BEFORE AN INDEPENDENT COMMISSIONER

IN THE MATTER of a resource consent application to demolish the Hydro Grand Hotel building and develop a mixed use office, apartment, retail and hotel complex at 10 The Bay Hill, Timaru

BRIEF OF EVIDENCE OF CHRISTOPHER JOHN WILSON

B2 - WEST ELEVATION

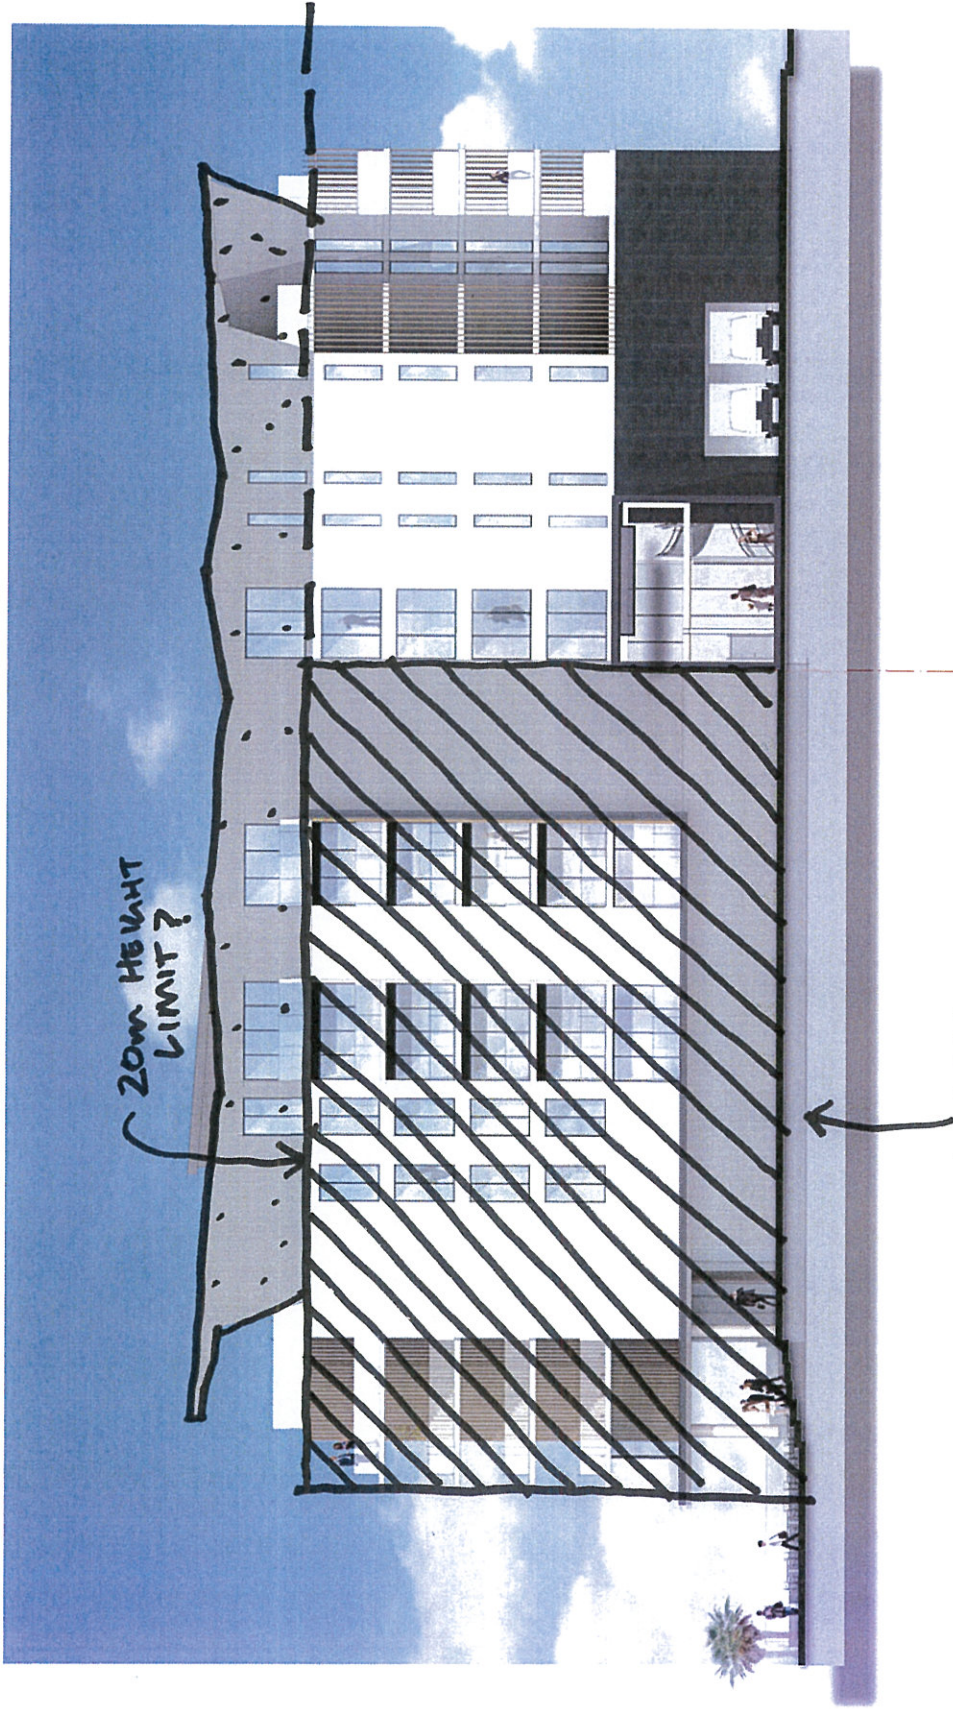
- 17 First, is how the height limit is shown on the plans.
- 18 The Applicant's drawings of the Apartment Building do not show the existing ground level or the 20m height limit so it is very difficult to establish the true degree of non-compliance, and assess the effects of that non-compliance. This is especially so from the perspective of the Trust's site. I have shown this by marking up the plan as set out in **Appendix 1**, page 1.

- 19 The height limit is shown on a cross section which I have had to rely on to assess the effects of the breach of the height limit. However, on this plan it is shown as a horizontal line, at two different heights, one for the Hotel and Apartment Buildings and another for the Office Building. This is presumably intended to reflect that the site slopes with a slight incline across the site to the west as described by Mr Burgess at paragraph 15 of his evidence. This is shown on page 2 of **Appendix 1**.

- (a) Mr Clease, at paragraph 44 of his evidence, describes the proposed buildings as "*generally consistent with the height limit*". I disagree with this statement because none of the proposed buildings meet the height limit, and at some points the height limit is exceeded by up to 3.9m (as indicated on my marked up drawings, attached as **Appendix 1**, see page **2** and **3**).

- 23 Based on the plans provided (albeit with the limitations I have identified), it appears that the bulk of the Apartment Building along the Trust Property boundary is in excess of 2.5m-3m above the height limit. Some exceedances are up to 3.9m. This is shown on **Appendix 1**, pages **2, 3** and **4**.

SOUTH ELEVATION

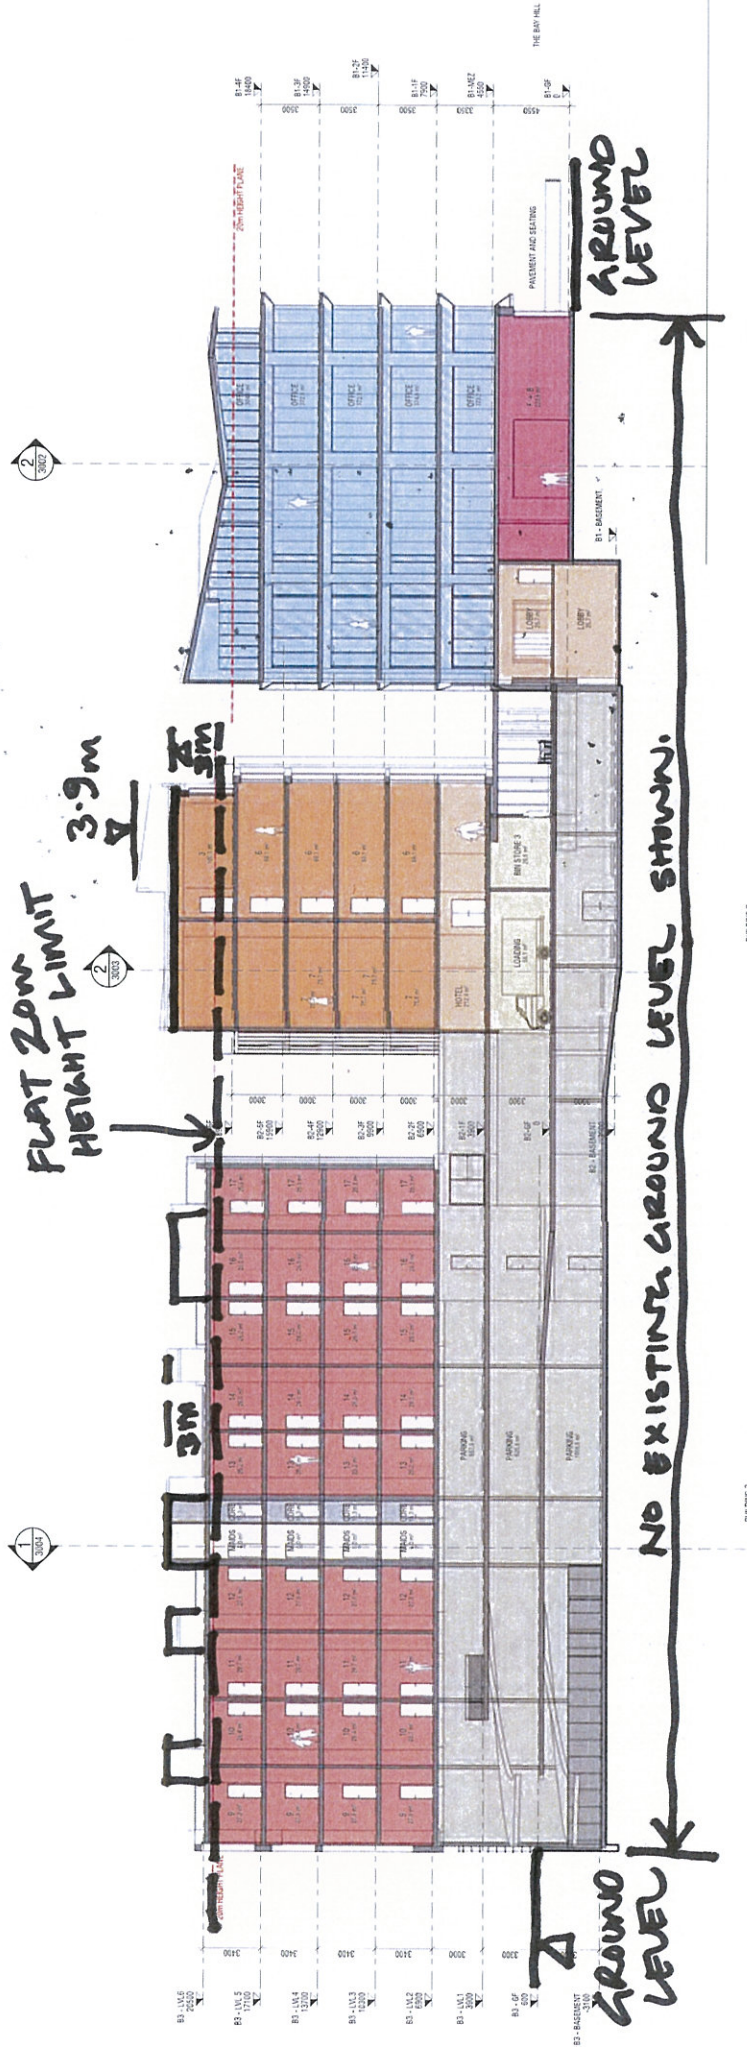
- 48 Assessing the effects of the Hotel Building is also made difficult by the lack of elevations and information.
- (a) The existing ground level has not been shown on the elevations for the Hotel Building which is again surprising, particularly given Mr Burgess describes the site as having a slight incline across the site to the west (by approximately 1.5m).⁵
 - (b) The Application does not include any north elevations of the Hotel Building which has made it difficult to assess the extent, and effect of the height limit breach. As only the east elevations have been provided, it has been difficult to establish the overall effect of the proposed Hotel Building.

49 This is shown on pages **5, 6 and 7** of **Appendix 1**.

50 The height of the Hotel Building results in multiple intrusions of the height limit by more than 1m (as stated in Mr Clease's evidence⁶) which has a greater effect on the Trust Property than what has been assessed.

2 B2 - NORTH ELEVATION
Scale: 1:100

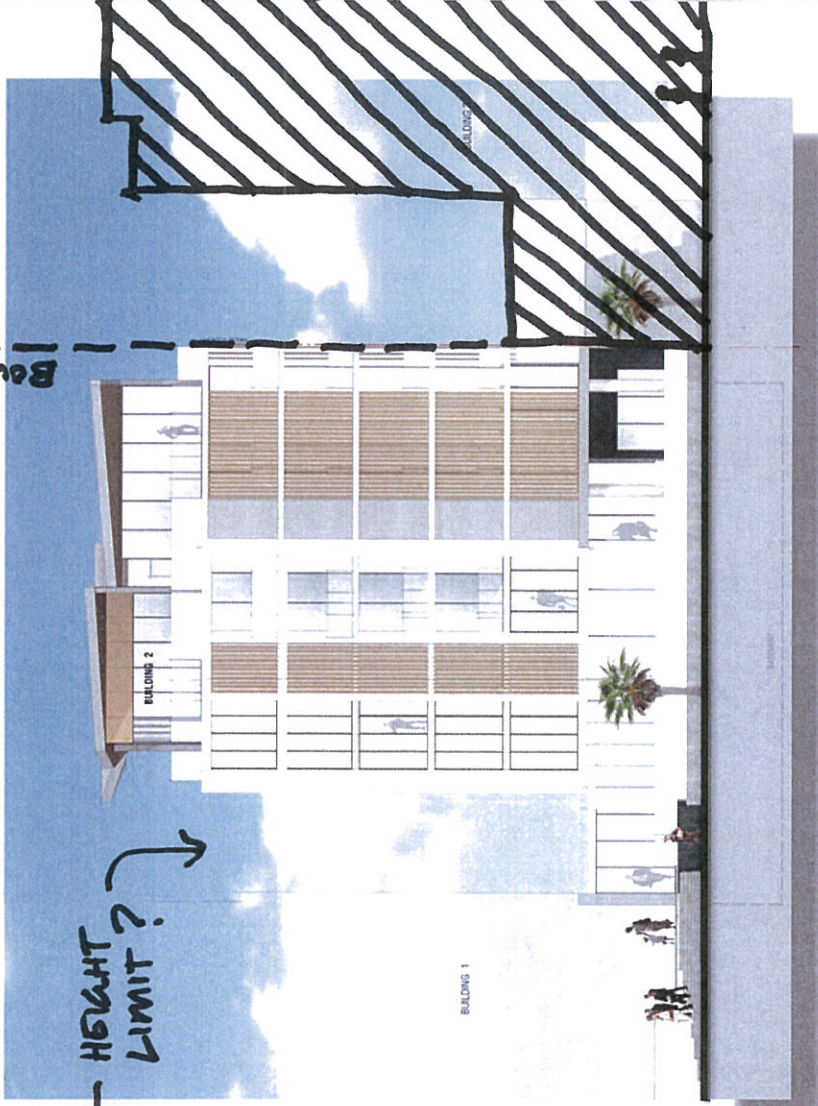
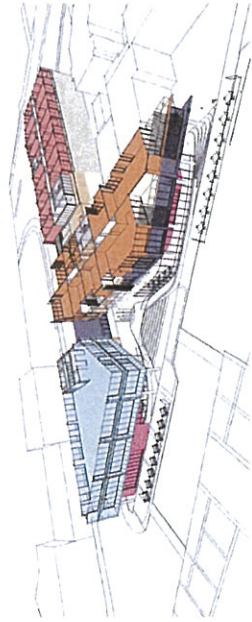
HEIGHT LIMIT
↑
